S16 Planning Application for Proposed Hospital Redevelopment with Minor Relaxation of Building Height Restriction in “Government, Institution or Community (7)” Zone and Areas Shown as ‘Road’ at Blocks A, B and C of Hong Kong Baptist Hospital, 222 Waterloo Road, Kowloon Tong, Kowloon

Responses to Comments

COMMENTS FROM RELATED DEPARTMENTS

Proposed Sewerage Plan (A3 1:1000)

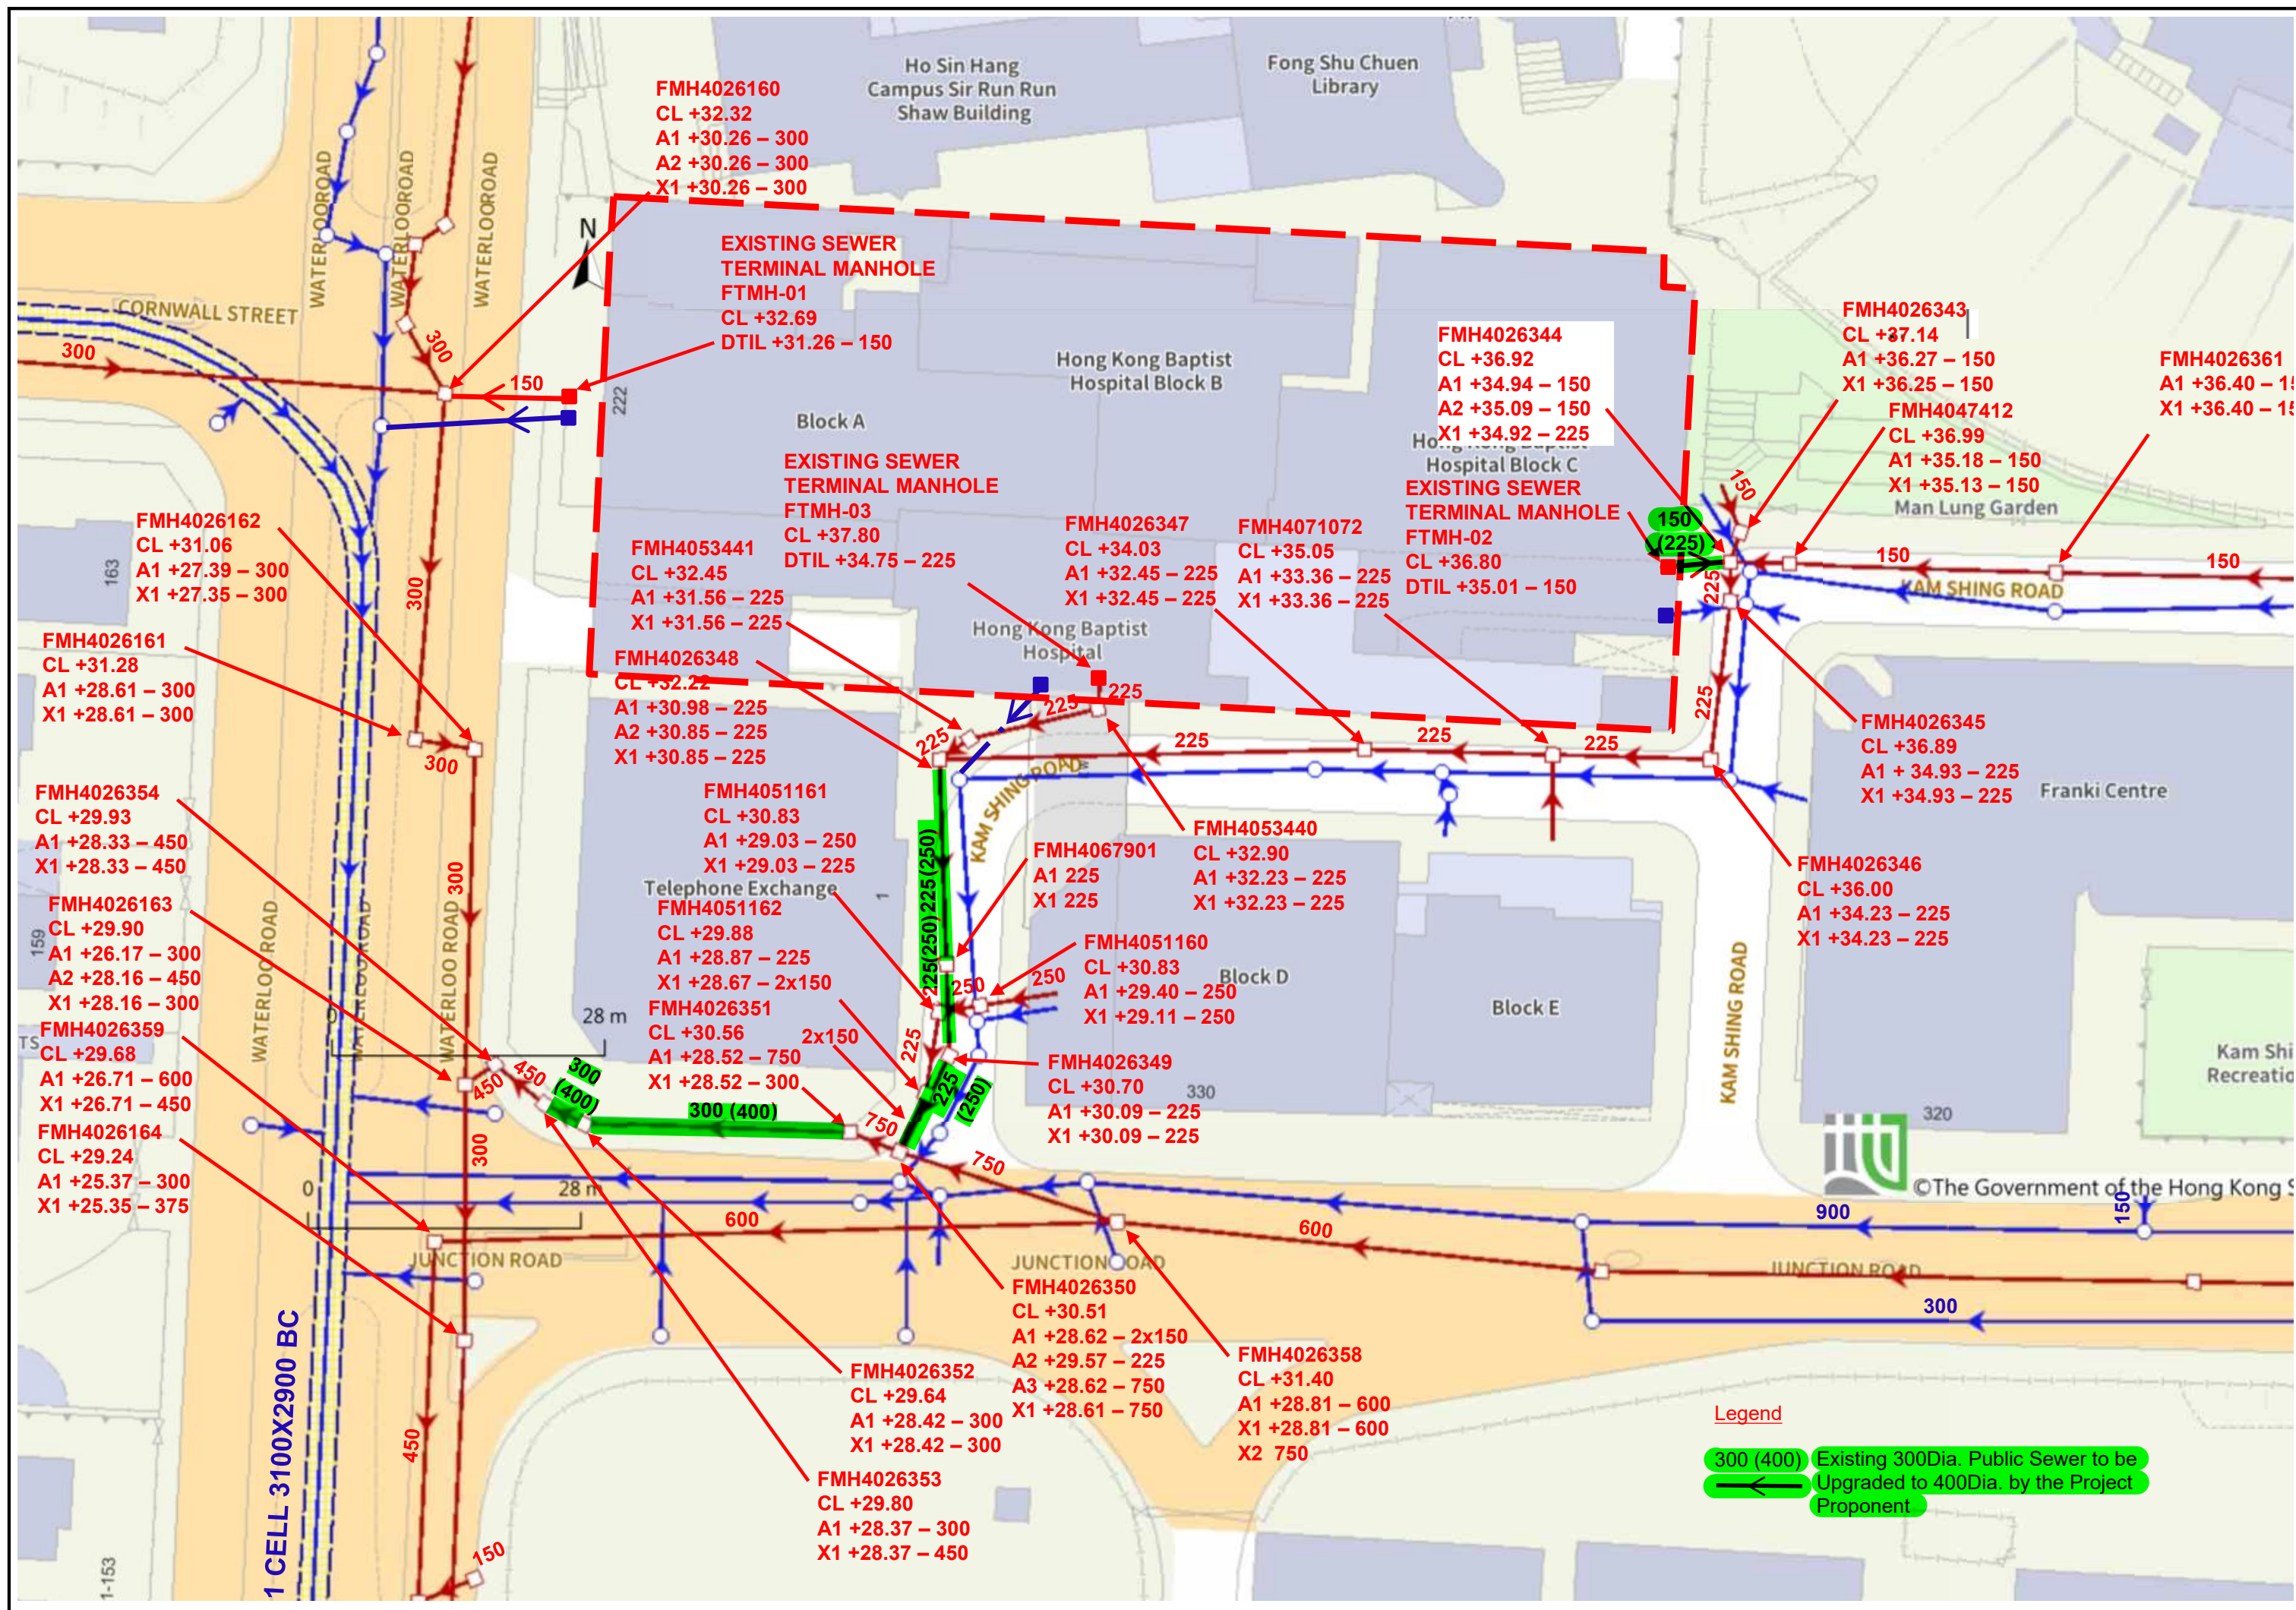
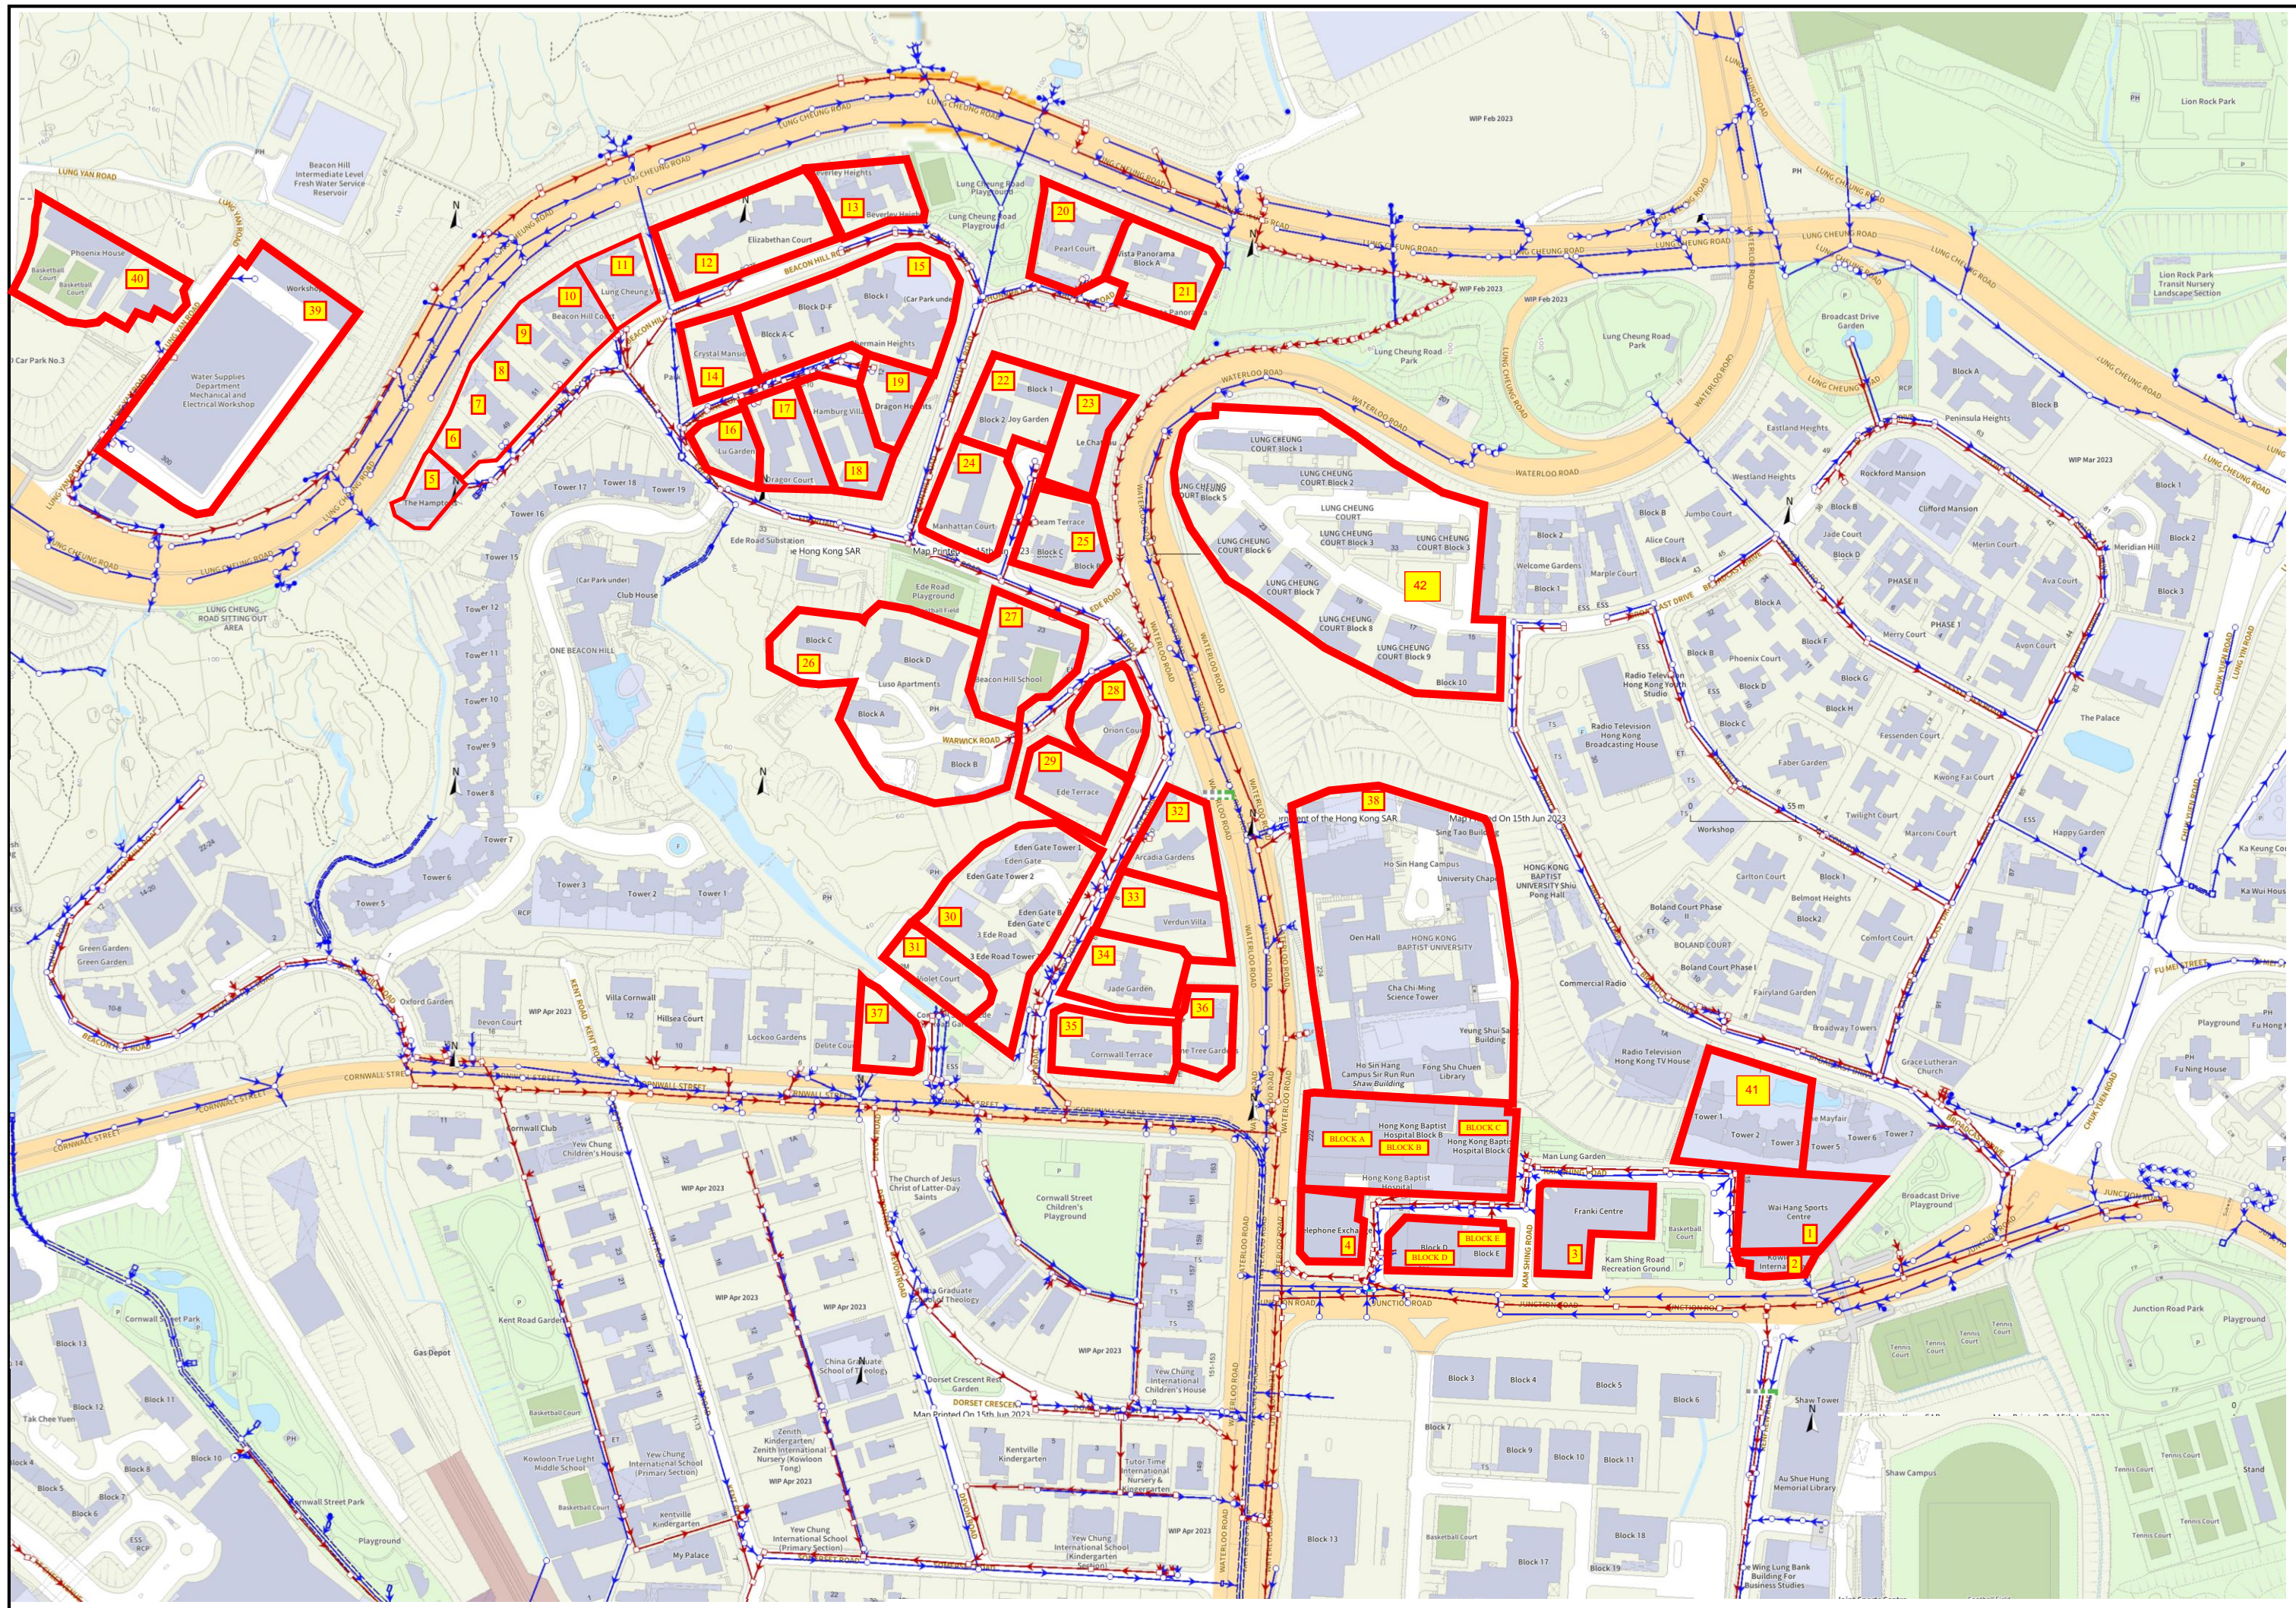
No.	Comments	Responses
	<p>Section 3.4</p> <p>(3) Based on the information provided in Plans 2 and 2A, it is noted that sewer segment between manholes FTMH-02 and FMH4026344 will be upgraded from 150mm dia. to 225mm dia.. Please include the description in the corresponding paragraph(s) of the SIA report for the sake of clarity.</p> <p>Section 3.4 and Appendix B (Table B2)</p> <p>(4) It is noted that the sewer segment between manholes FMH4026348 and FMH4026349 will be upgraded from 225mm dia. to 250mm dia. pipe. In view of the size (i.e. 225mm dia.) and utilization rate (i.e. 94.8%) of the subsequent sewer segment between manholes FMH4026349 and FMH4026350, it is recommended to upgrade the sewer segments between FMH4026348 and FMH4026350 as mitigation measure with reference to the DSD's Sewerage Manual.</p> <p>Appendix B (Table B1)</p> <p>(5) Regarding the ADWF estimation for in-patient, please advise the assumption of UFF adopted, with consideration of the nature of residence instead of the UFF of commercial employee under the business type J11 (Community, Social & Personal Services). Please review and revise the estimated sewage flow as appropriate.</p> <p>(6) Regarding the ADWF estimation for hospital visitors, it appears that adjustment factor is applied in the calculation of ADWF. Please state the assumption adopted in the calculation</p>	<p>Noted and description is included in Section 3.4 of the revised SIA Report (Appendix A).</p> <p>The sewer segments between FMH4026348 and FMH4026350 will be upgraded to 250mm dia. sewer. Plans 2 and 2A, Section 3.4 and Appendix B (Table B2) are updated in the revised SIA Report (Appendix A).</p> <p>Considering the residence nature of in-patient, we proposed to adopt resident UFF (Institutional and Special Class) of 0.190m³/day for in-patient. Table B1 of Appendix B is updated in the revised SIA Report (Appendix A).</p> <p>It is assumed that HKBH peak visiting hours are 12:00pm to 2:00pm and 5:30pm to 7:30pm (4 hours). The estimated sewage flow for visitors is pro-rata from daily flow (8 hours) respect with the visiting duration of 4 hours. This assumption is stated in the</p>
